Huntington County Community School Corporation
Secure Vestibule Project (Andrews, Flint Springs, Lincoln, Salamonie)

Project # 2025.0015

April 10, 2026

ADDENDUM NO. A-1

[ADDENDUM A-1] EXHIBIT #1 – Revised Sheet
A6.0 Door Schedules and Details

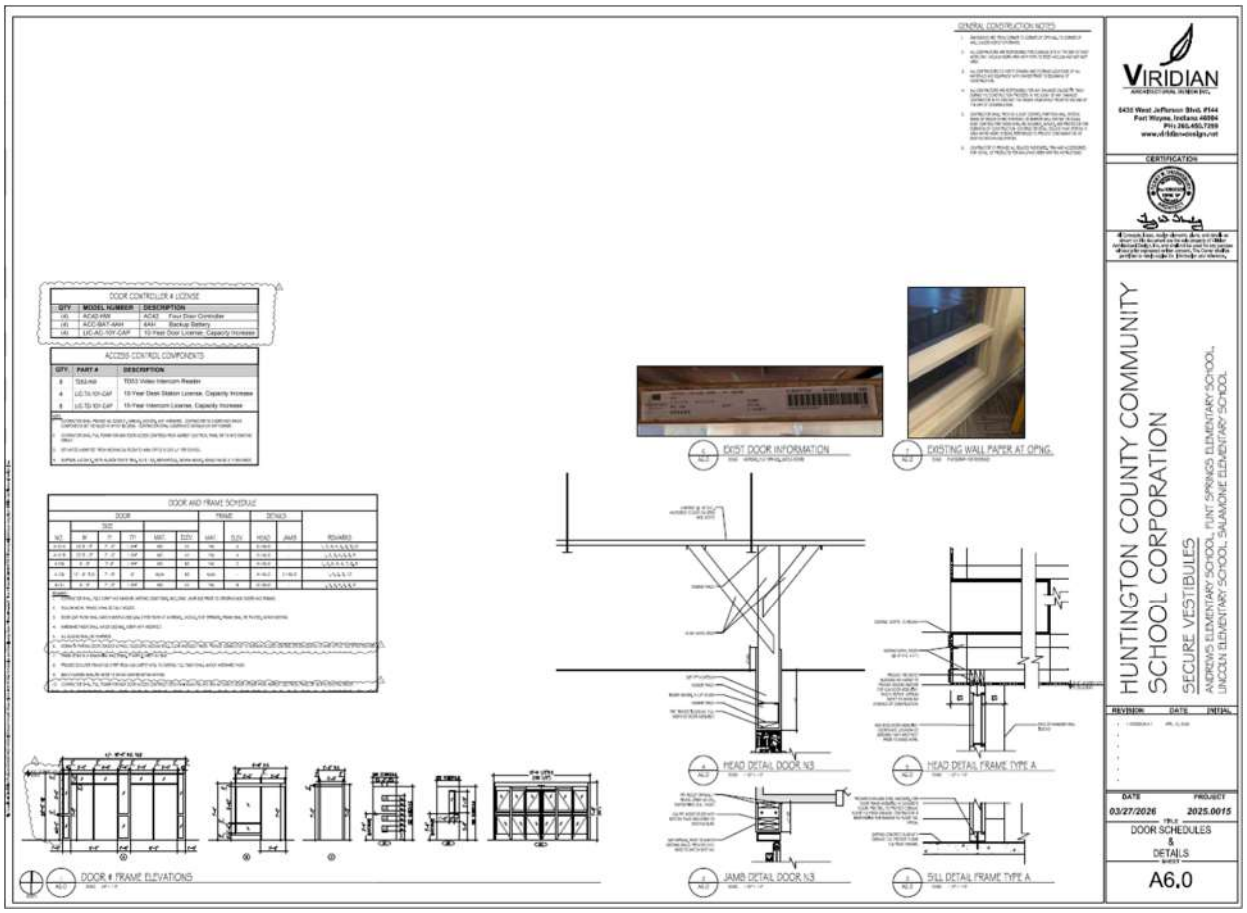
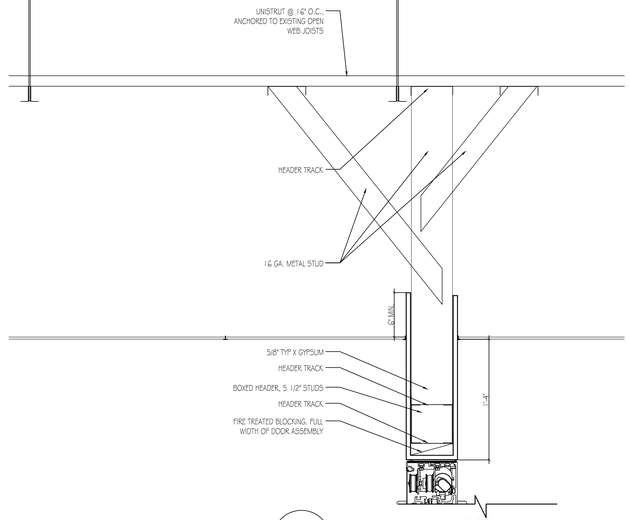
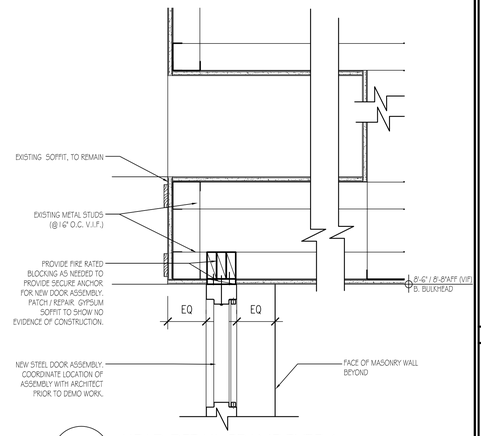
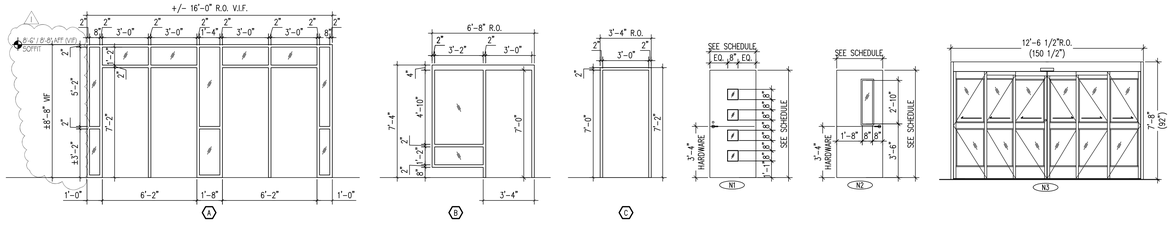
Item: **A-1.1**
Location: A6.0 Door Schedules and Details [Exhibit #1]
Description: **ADDED** - **Verkada AC42-HW Door Controller and License**
Contractor shall include in Bid the Verkada AC42-HW door controller per school. This will be able to properly handle all (9) of the access-controlled doors and the dry contacts needed for the sliding door in conjunction with the Verkada TD53-HW Video Intercom, Security, Door Access system.

Item: **A-1.2**
Location: A6.0 Door Schedules and Details (door A126)
Description: **REVISED** - **DOOR A126 - 6 Panel Telescopic Automatic Sliding Door (Dorma Bi-Parting Door ESA300T 6 Panel Medium Stile)**
Revision doors shall be Medium stile doors with 10” bottom rails. Additionally, the sliding doors shall be tied into the Verkada Access Control system.

5. ALL GLAZING SHALL BE TEMPERED.
6. DORMA BI-PARTING DOOR ES430OT 6 PANEL TELESCOPIC MEDIUM STILE, CLEAR ANODIZED FINISH. PROVIDE CONNECTION TO VERKADA ACCESS CONTROL SYSTEM LOCATED IN MAIN OFFICE. SEE SPECIFICATIONS.

[ADDENDUM A-1] EXHIBIT #2 – Revised Sheet
S-A1.0 Salamonie Enlarged Plans Interior Elevations & Photographs

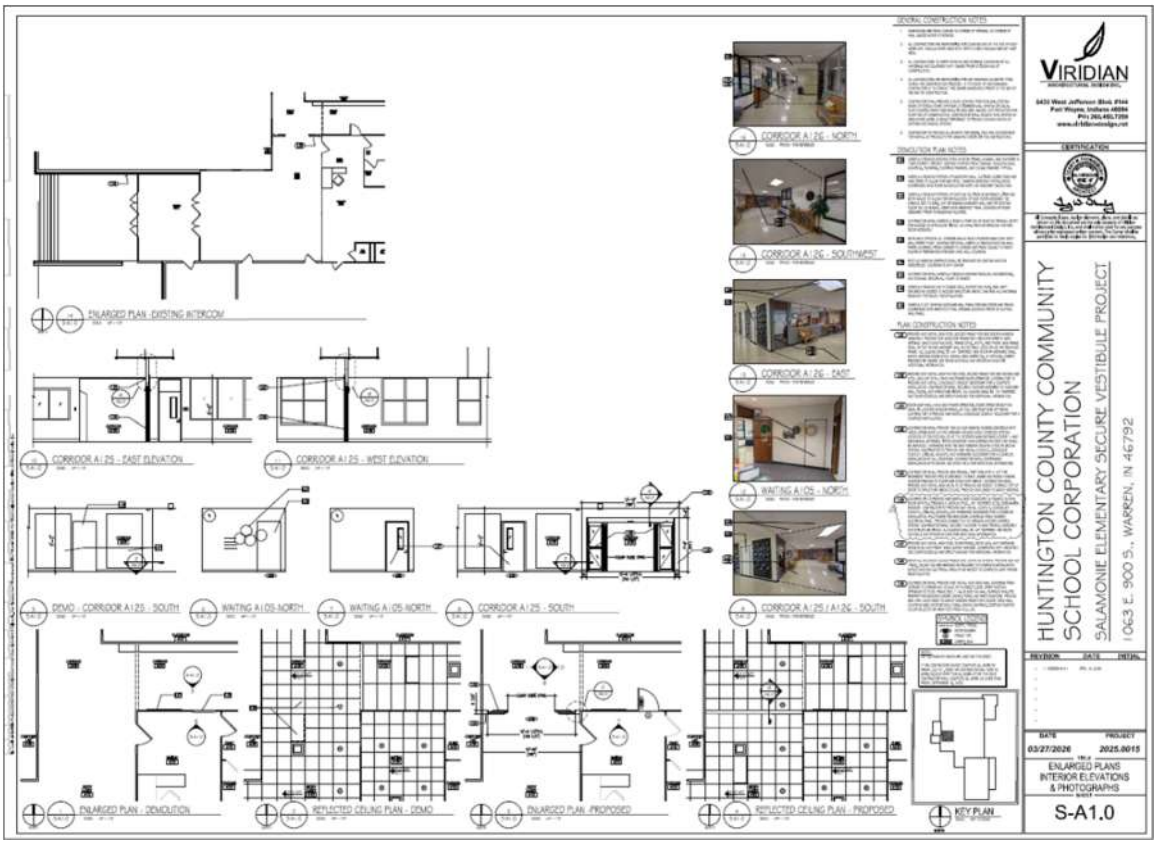
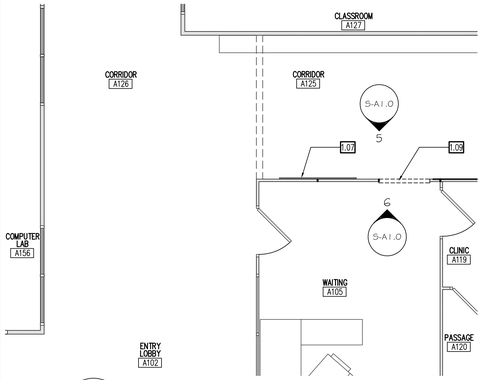
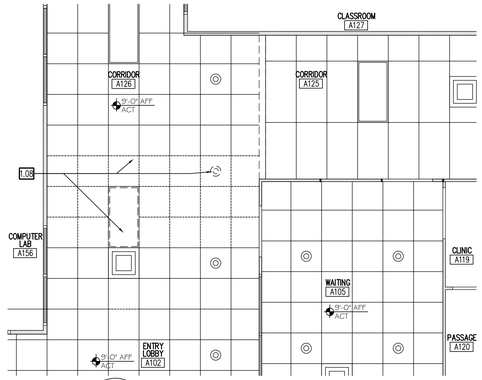
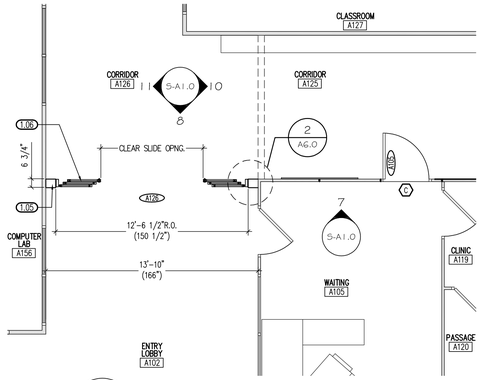
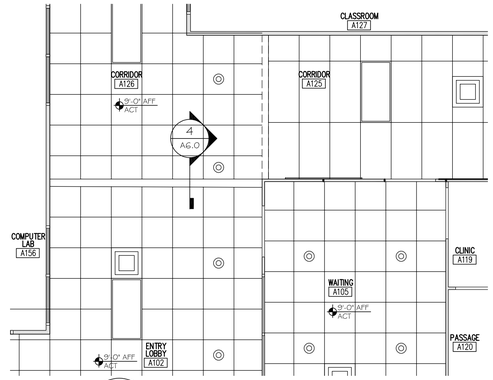
Item: **A-1.3**
Location: S-A1.0 Salamonie Enlarged Plans Interior Elevations & Photographs
Description: **REVISED** – **Note 1.6 to include Medium Stile and Verkada control requirement.**

1.06 CONTRACTOR TO PROVIDE AND INSTALL NEW TELESCOPIC AUTOMATIC SLIDING DOOR WITH FULL BREAKOUT, MEDIUM STILE, 1/4" TEMPERED LITES; DORMAKABA ES400DT. CONTRACTOR TO PROVIDE AND INSTALL CONDUIT, CONCEALED CONDUIT, CABLING, MOUNTS, AND HARDWARE NECESSARY FOR A COMPLETE INSTALLATION. PULL POWER FOR NEW DOOR CONTROLS FROM NEAREST ELECTRICAL PANEL. PROVIDE CONNECTION TO VERKADA ACCESS CONTROL SYSTEM. CONTRACTOR SHALL SECURELY ANCHOR TO NEW DRYWALL ASSEMBLY AND STRUCTURE ABOVE. ALL GLAZING SHALL BE 1/4" TEMPERED. SEE DOOR SCHEDULE AND SPECIFICATIONS FOR ADDITIONAL INFORMATION.
